MIAMISBURG CLOSURE PROJECT RISK BASED END STATE VISION

DRAFT
February 2004

Figure 2.1b Regional physical and surface interface - RBES

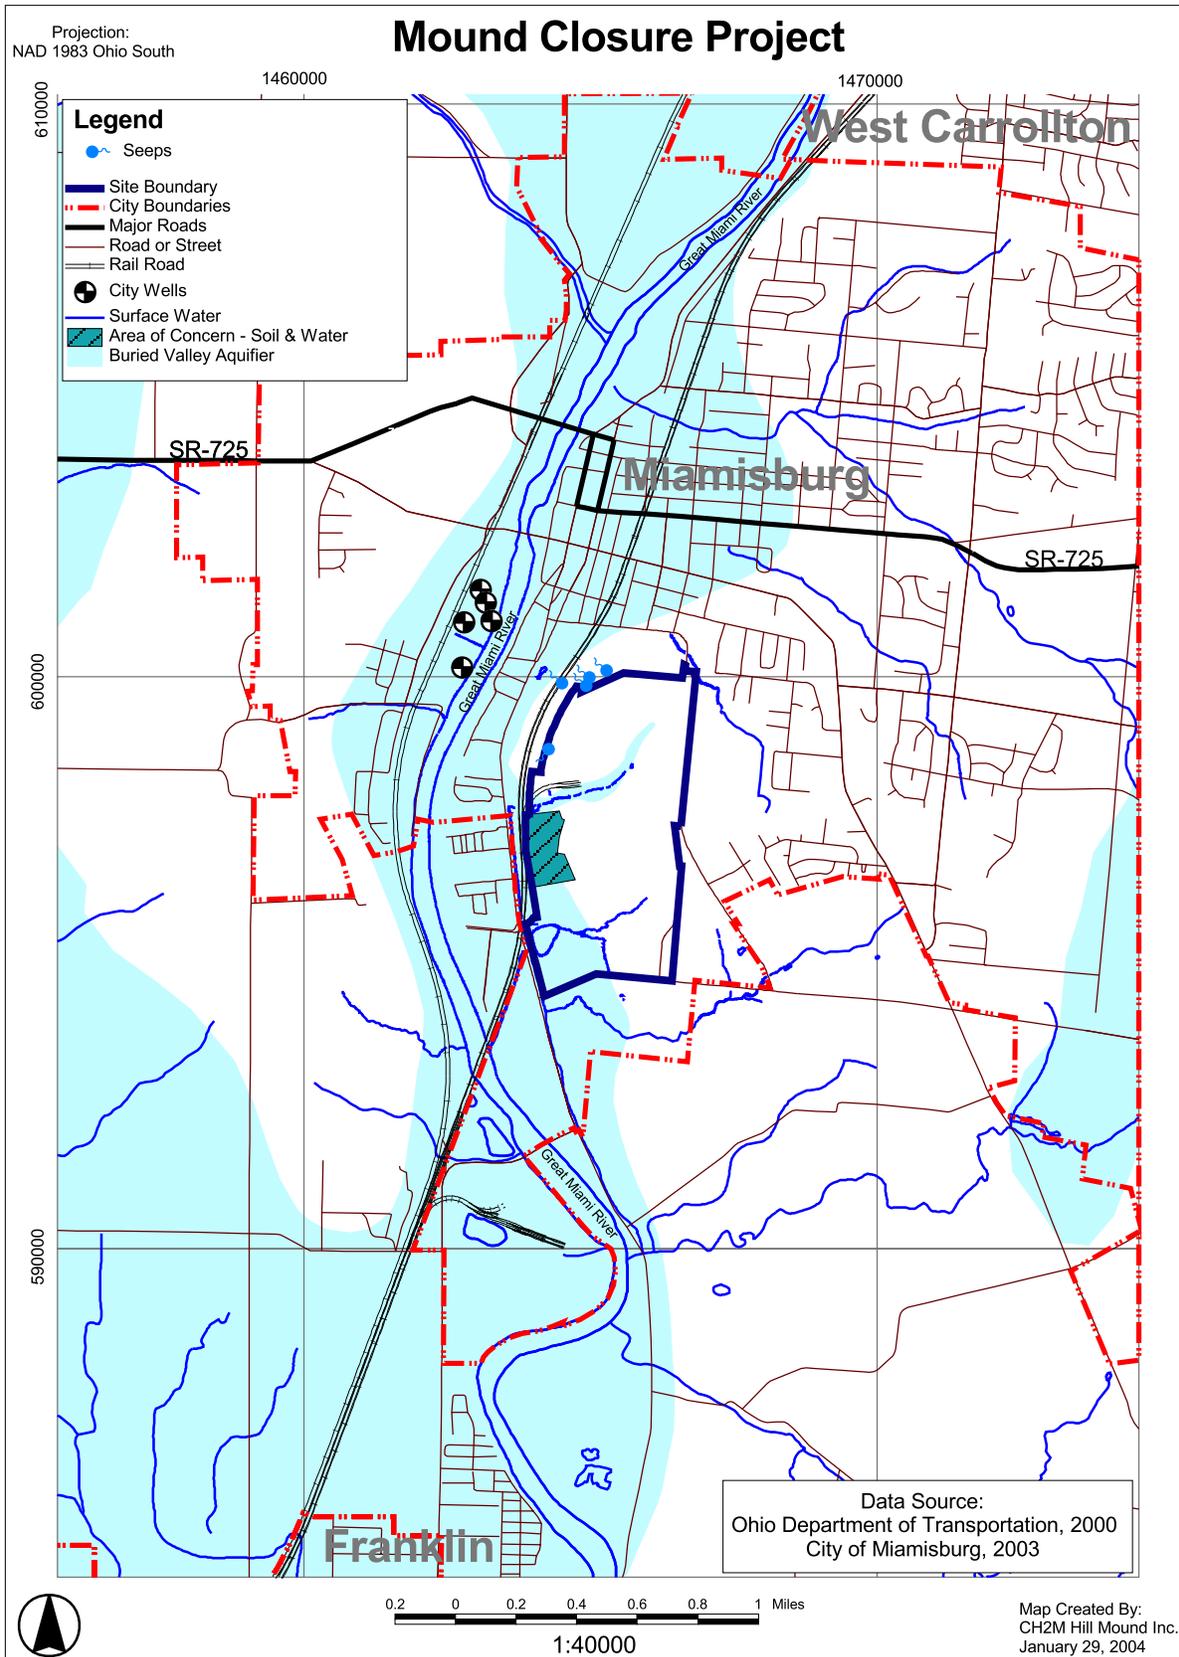
26. Figure 2.1b. 1) Correction, there are five city production wells. 2) The area of groundwater concern extends beyond the site boundary. This should be corrected on the map.

26. Figure 2.1b. 1) Correction, there are five city production wells. 2) The area of groundwater concern extends beyond the site boundary. This should be corrected on the map.

23. Page 19. It would be helpful in fully comprehending the document to have all of the references.
24. Figure 2.1b. 1) Correction, there are five city production wells.

Figure 2.2b Regional human and ecological land use - RBES

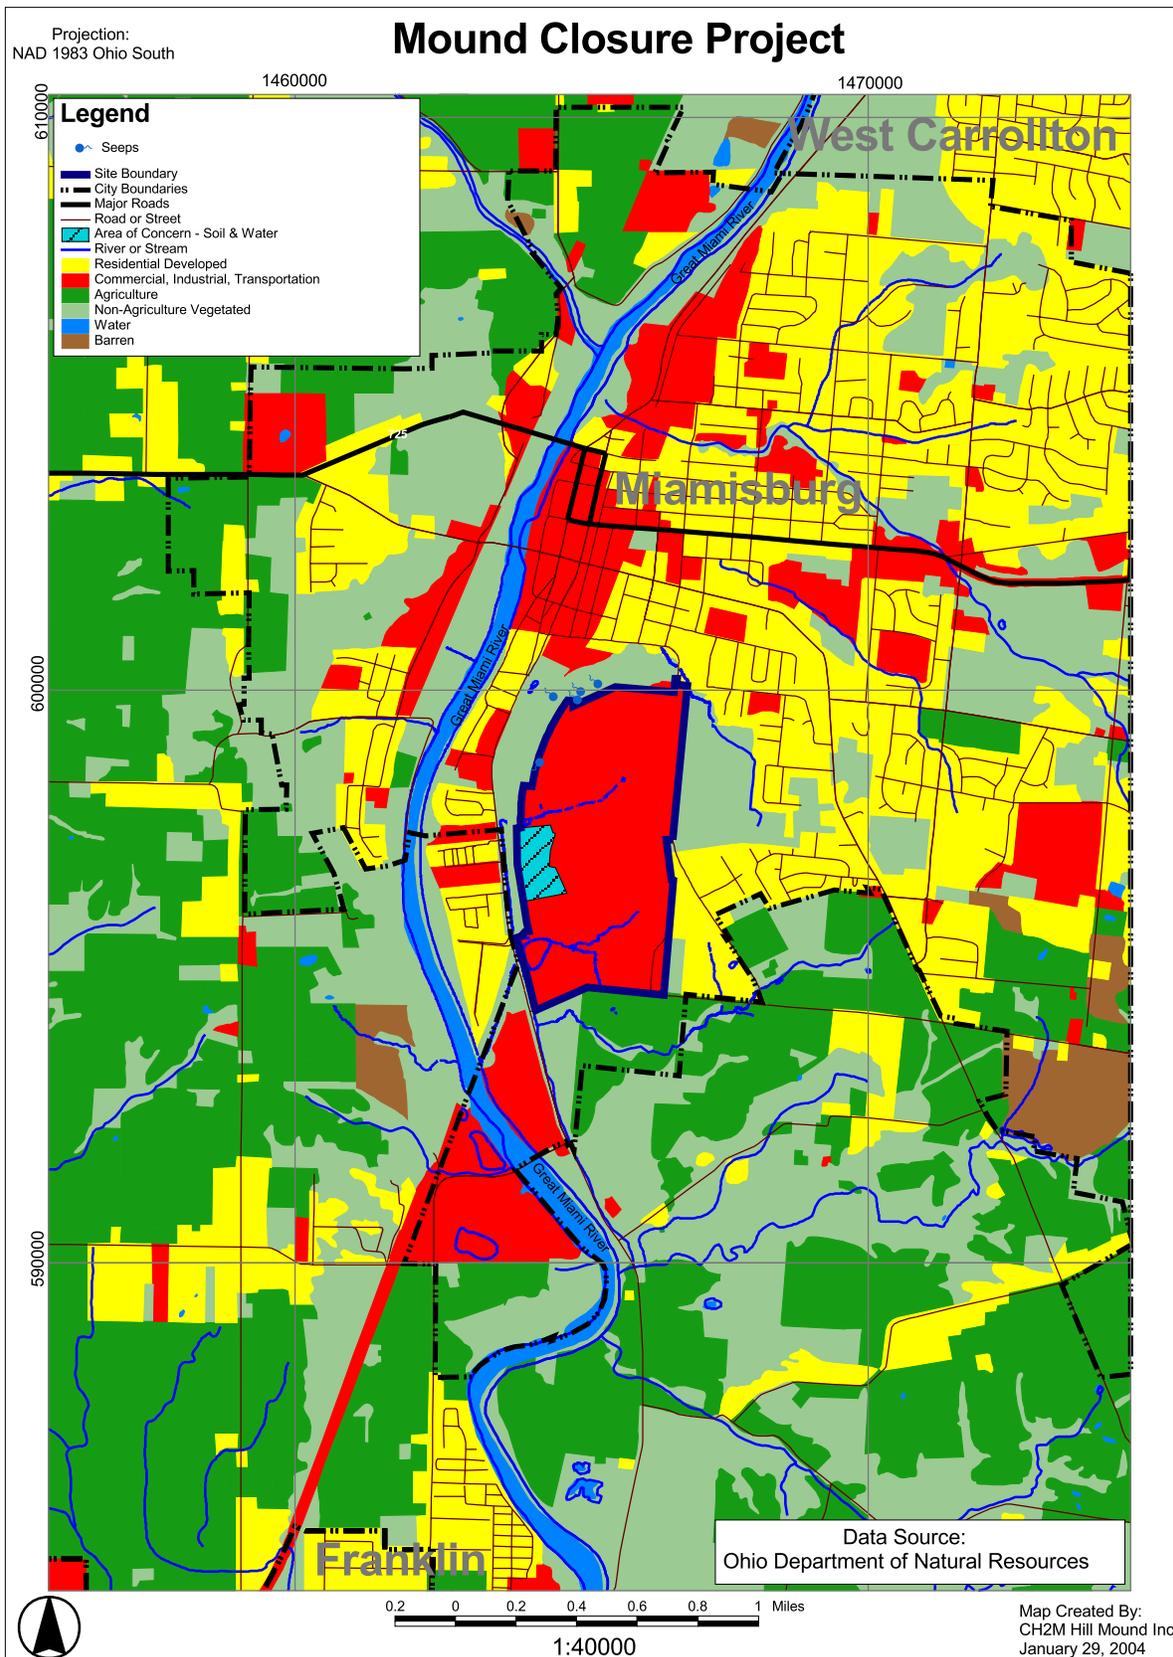
27. Figure 2.2b. The area of groundwater concern extends beyond the site boundary. This should be corrected on the map.
28. Figure 3.1b. 1) Legend clarification – change landfill to mixed waste landfill. 2) The area of groundwater concern extends beyond the site boundary. This should be corrected on the map.

27. Figure 2.2b. 1) The area of groundwater concern extends beyond the site boundary. This should be corrected on the map.

Figure 3.1b Site physical and surface interface - RBES

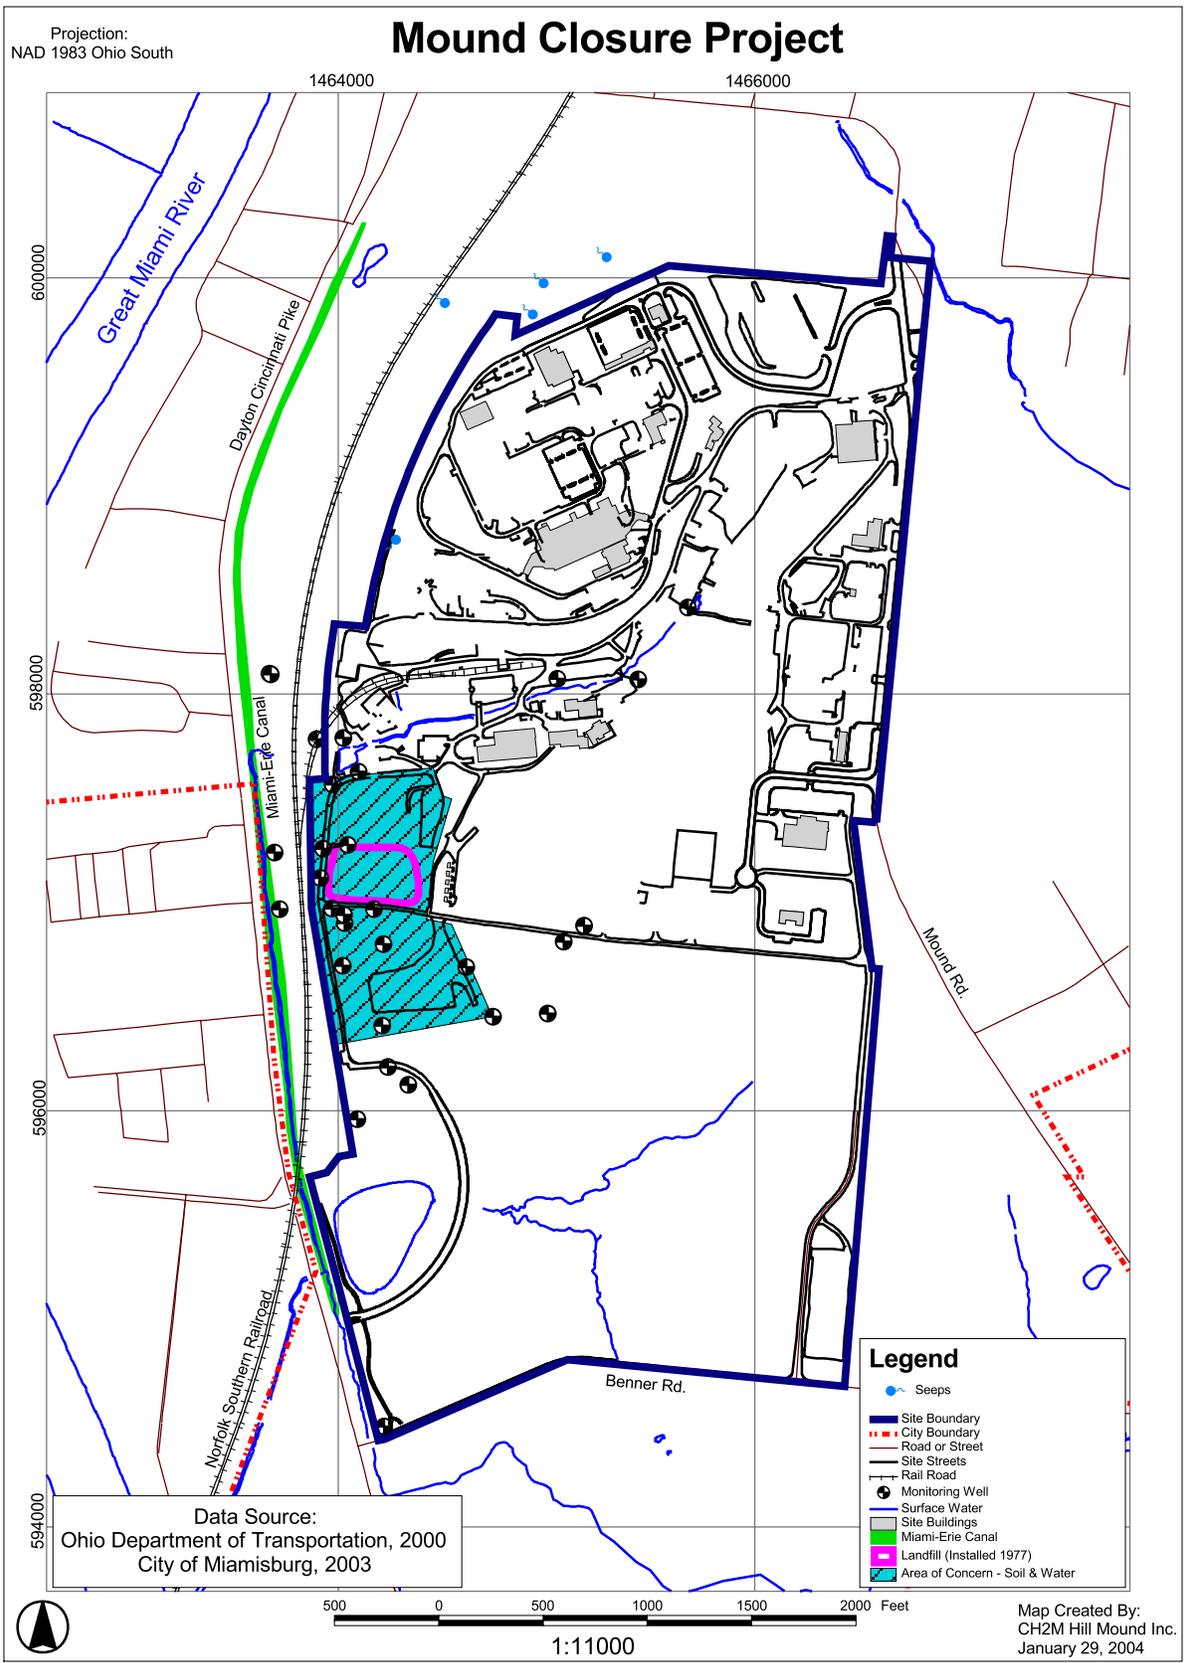
28. Figure 3.1b. 1) Legend clarification – change landfill to mixed waste landfill. 2) The area of groundwater concern extends beyond the site boundary. This should be corrected on the map.

33. Figure 3.1b. 1) Legend clarification-change landfill to mixed waste landfill. 2) The area of groundwater concern extends beyond the site boundary. This should be corrected on the map.

31. **Figure 3.1b** – In the legend under Monitoring Wells, place the following “(estimated)”.
32. **Figure 3.3b** – The figure indicates that MMCIC is the legal owner of the entire site. If the landfill remains, will MMCIC assume ownership of this area?

- 31. Figure 3.1b** – In the legend under Monitoring Wells, place the following “(estimated)”.

25. Figure 3.1b. 1) Legend clarification – change landfill to mixed waste landfill. Landfill is too generic of a term. We suggested "mixed waste" as a clarification based on Bob Warther's \$50 million cost estimate to remove the landfill which he said was based on the landfill containing mixed waste. If DOE intends on leaving a landfill, the public has a right to know what type of waste is contained in it. Has the landfill waste ever been characterized?

Figure 3.2b Site human and ecological land use - RBES

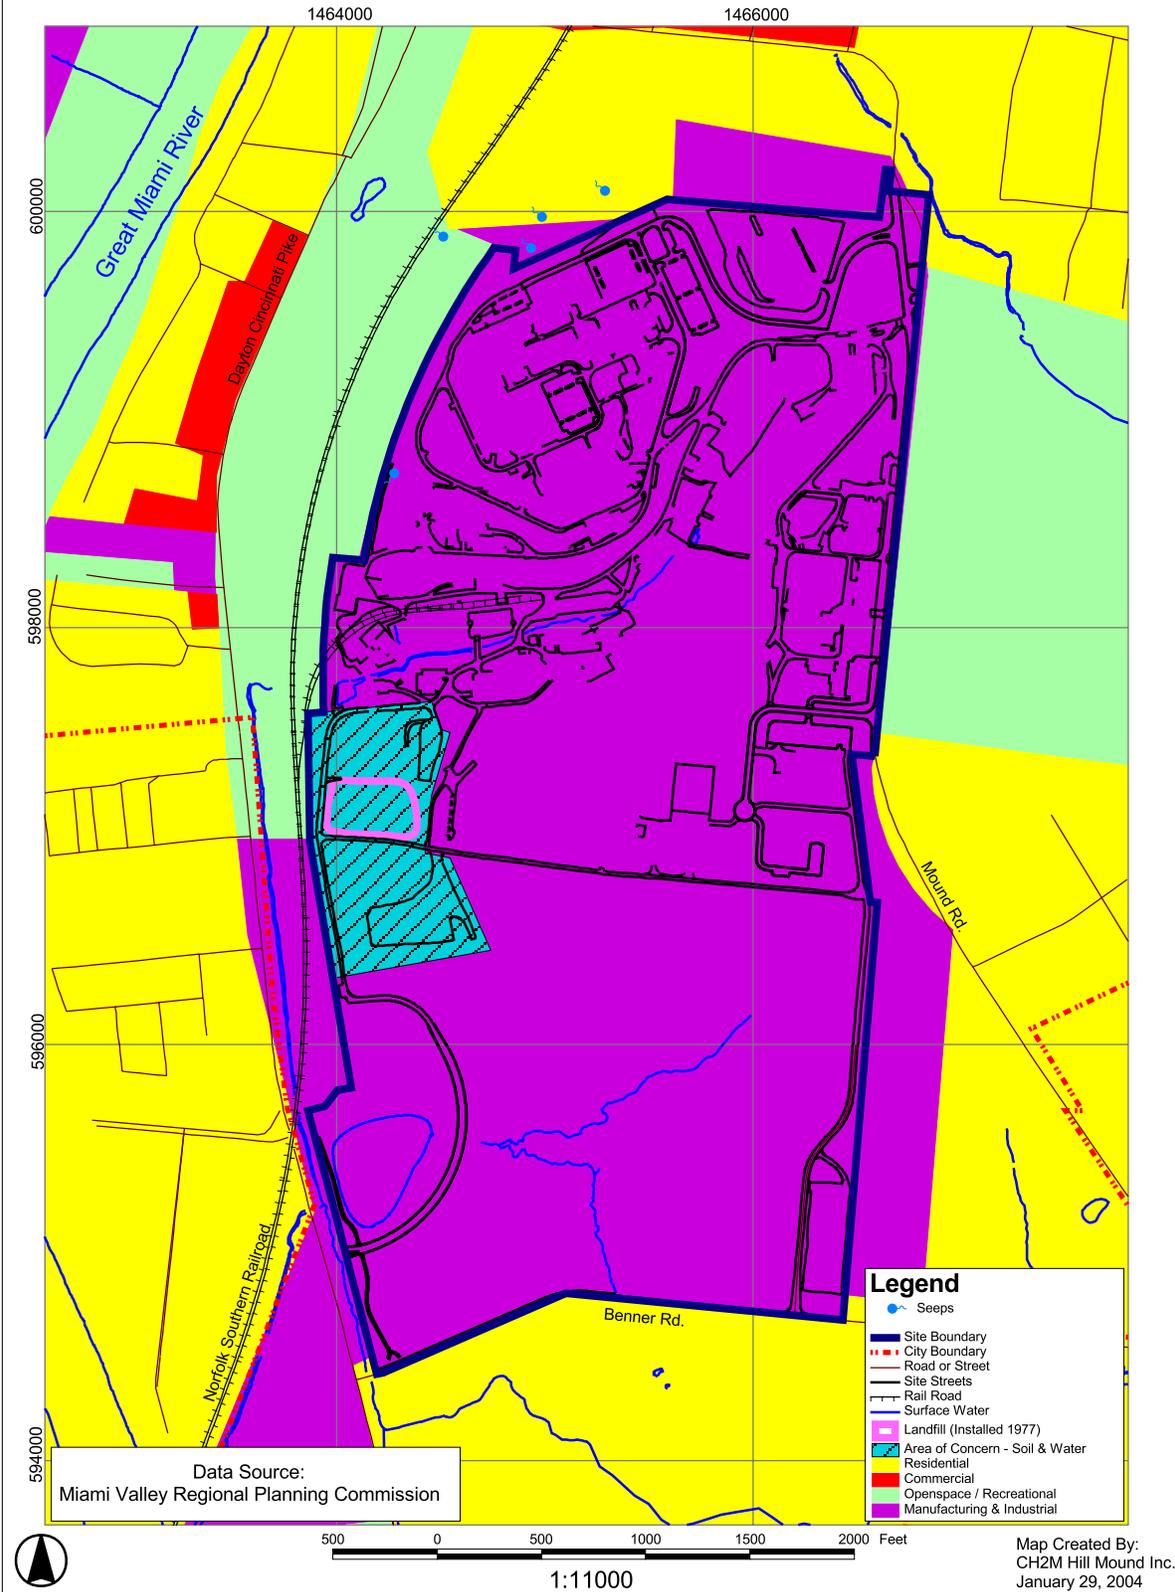
29. Figure 3.2b. 1) Legend clarification – change landfill to mixed waste landfill. 2) The area of groundwater concern extends beyond the site boundary. This should be corrected on the map.

29. Figure 3.2b. 1) Legend clarification – change landfill to mixed waste landfill. 2) The area of groundwater concern extends beyond the site boundary. This should be corrected on the map.

Figure 3.3b Site legal ownership - RBES

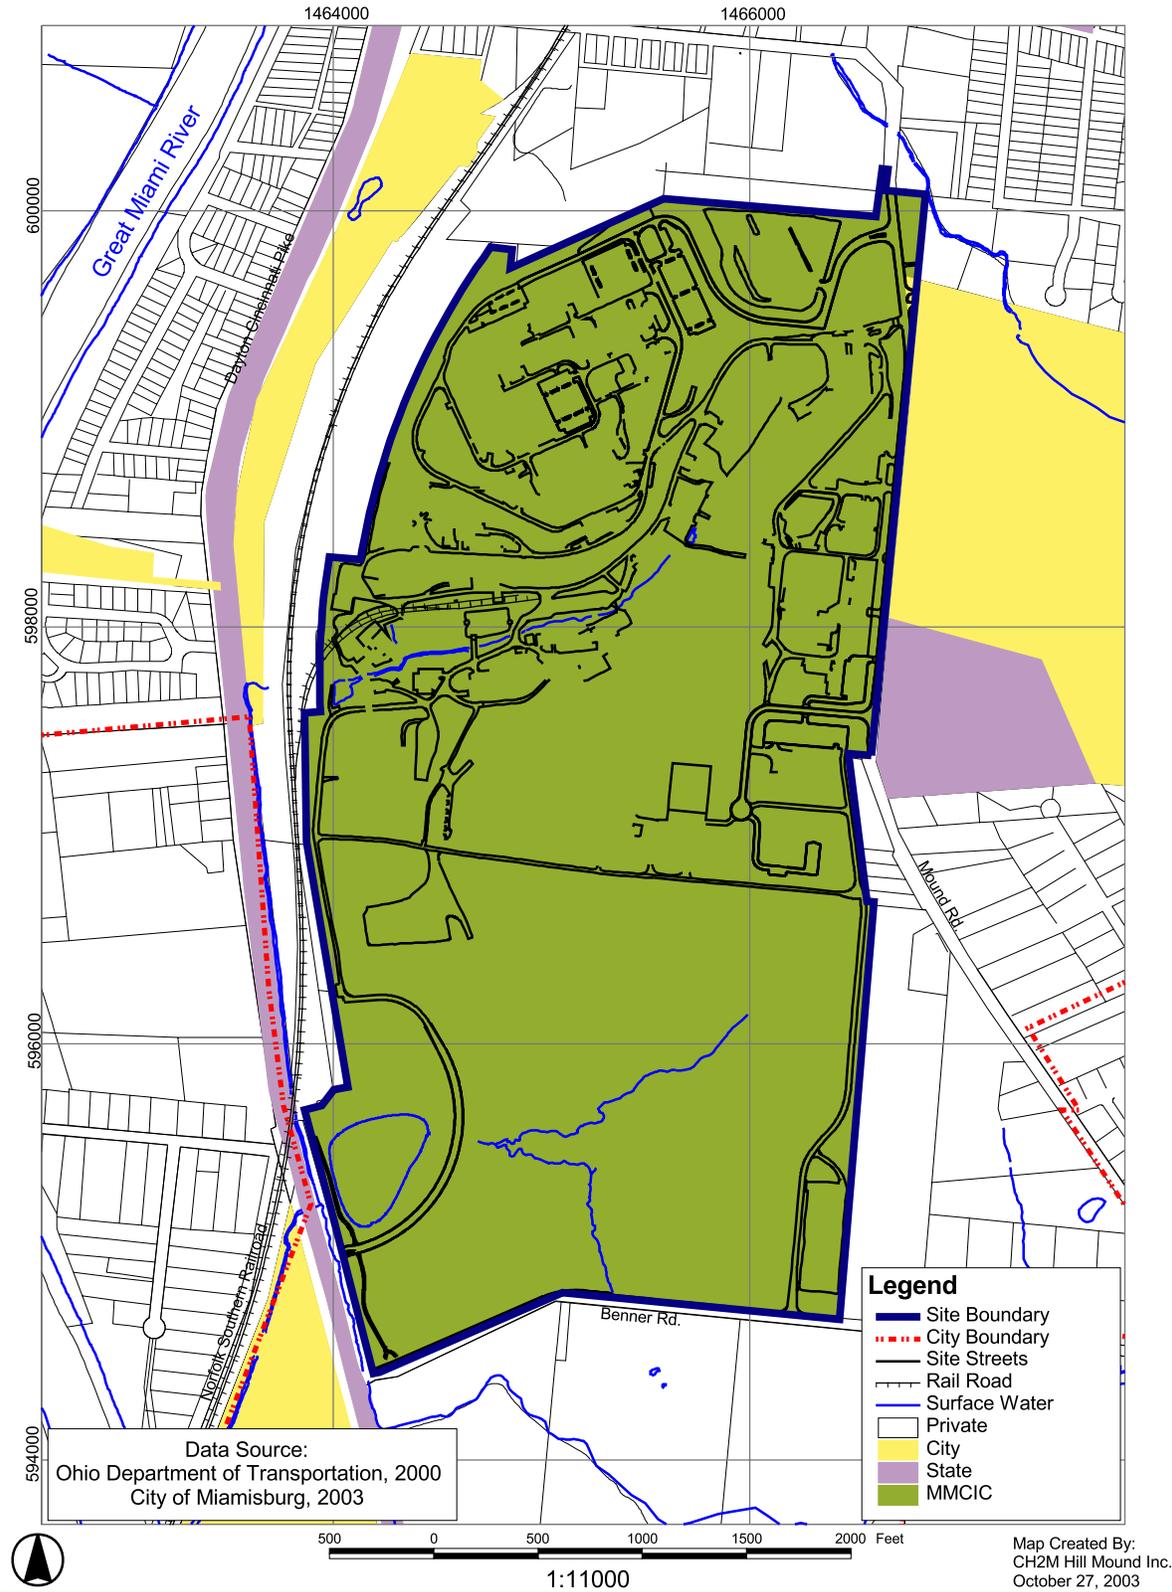
- 32. Figure 3.3b** – The figure indicates that MMCIC is the legal owner of the entire site. If the landfill remains, will MMCIC assume ownership of this area?

11. **Page 18, Last paragraph** – See specific comment 7.
12. **Figure 3.3b** – Since this is a vision document, two figures should be used to show site ownership. One as is, with MMCIC owning the site and one with MMCIC owning all of the site except the RBES Hazard Area 1.
